SERVICE BULLETIN

SB-030525-A

ID NUMBER & REVISION: SB-030525-A
SUBJECT: Repair ELT GPS Connector Wiring
RELEASE DATE: 07 March 2025
EFFECTIVE DATE: 07 March 2025
SUPERSEDES NOTICE: SD-111324-A (upon completion of this Notice)

Figure 1. Incorrect Wiring (left), Correct Wiring (right)

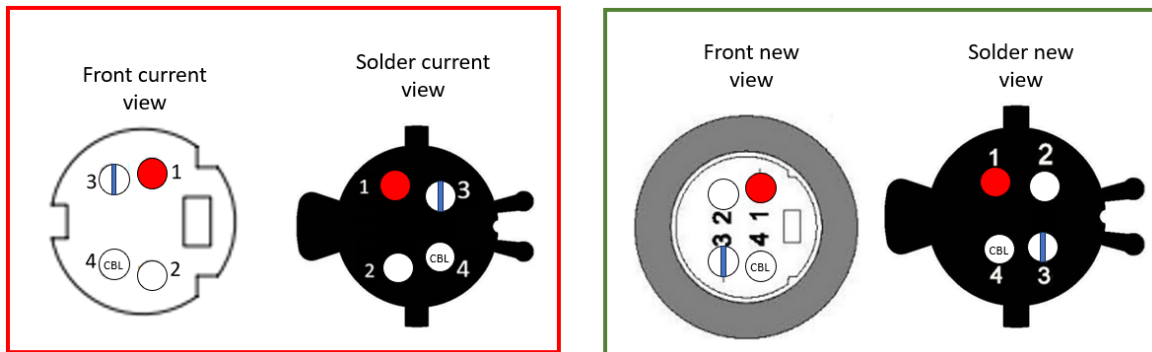
ICON has identified that the ELT GPS Connector, D9157P, may have been pinned incorrectly. This can drain the ELT battery, which may prevent the ELT from functioning. This may be recognized by a failed self-test, a red light flashing on the remote panel, and/or audible squelching from the overhead speaker.

REQUIRED ACTION: Re-pin the GPS Connector (D9157P) and re-install. This repair addresses the issue identified in *SD-111324-A ELT GPS Connector Wiring (Interim)*.

Figure 5

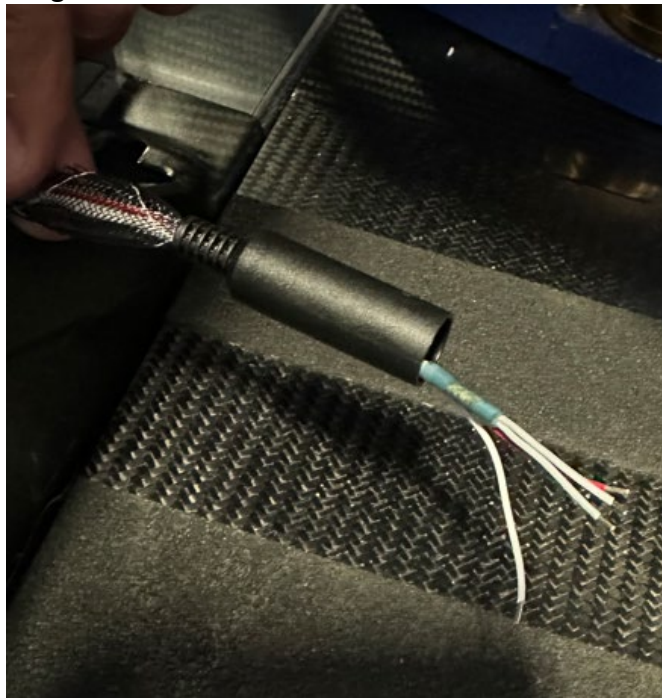
7. Remove connector body (two pieces). (Figure 5)

*Figure 7*

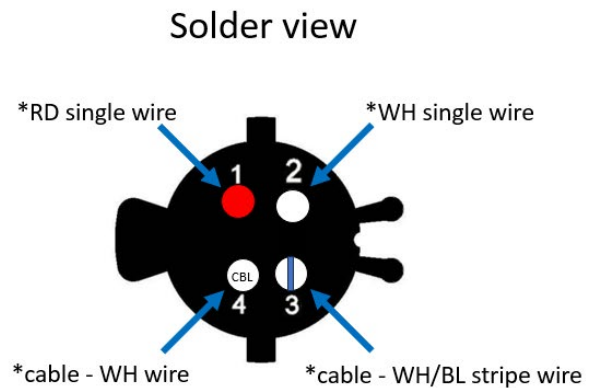
9. If removed, reapply connector label "D9157P".
10. Slide new connector plastic cover into the bundle back to where F4 tape is and identify which wires come from the multiconductor and which are single wires. (Figure 7)
 - a. You must have the following:
 - i. A two-conductor cable with a WH wire and a WH/BL stripe wire.
 - ii. RD single wire.
 - iii. WH single wire.

Figure 9

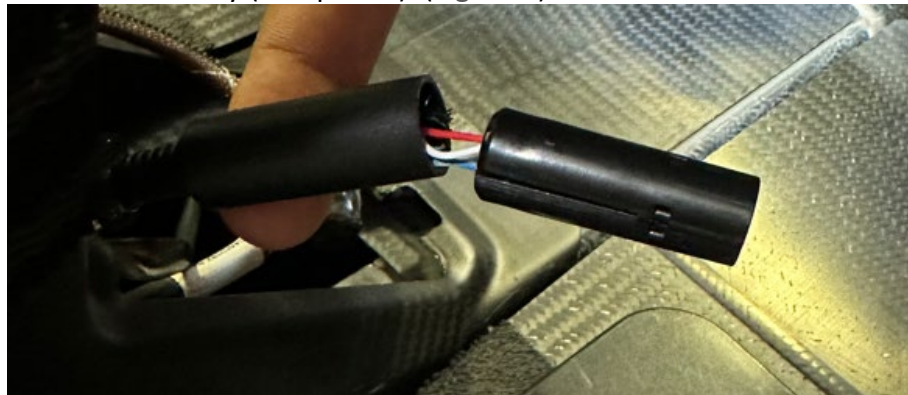
12. Assemble new connector body (two pieces). (Figure 9)

Figure 10

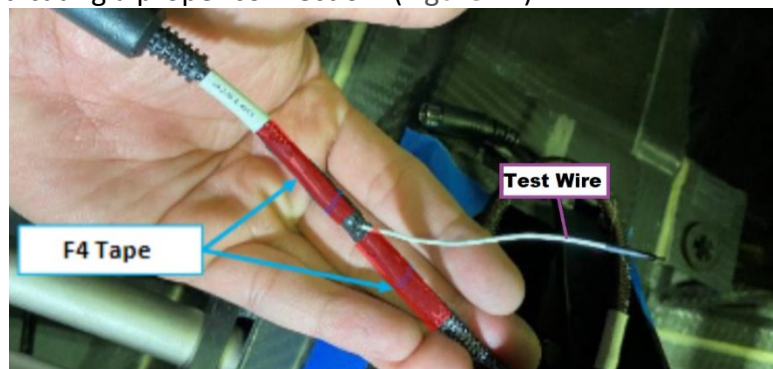
13. Slide the plastic cover up to the front of the connector. (Figure 10)
